**Subject** ▶ Change on Compression Spring 8 and Sleeve 8

**For Models** ▶ 8411D,8411DW (10mm Codless Hammer Drill)

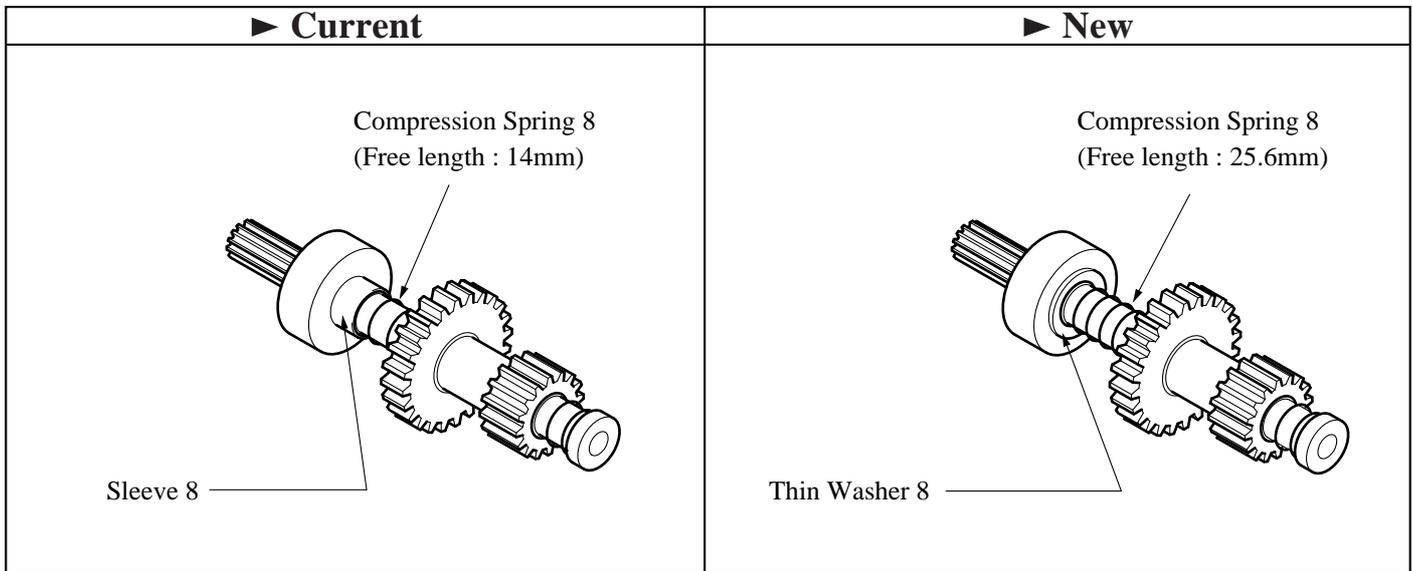
**Description** ▶ As illustrated below, two parts have been changed against closing of Compression Spring 8.

Item No.	Current part	Q'ty	I/C	New part	Q'ty	Note
41	Compression Spring 8 231025-5	1	No	Compression Spring 8 233104-5	1	Interchangeable as a set
33	Sleeve 8 257550-8	1	No	Thin Washer 8 253339-2	1

8411DW : From serial No.13495G
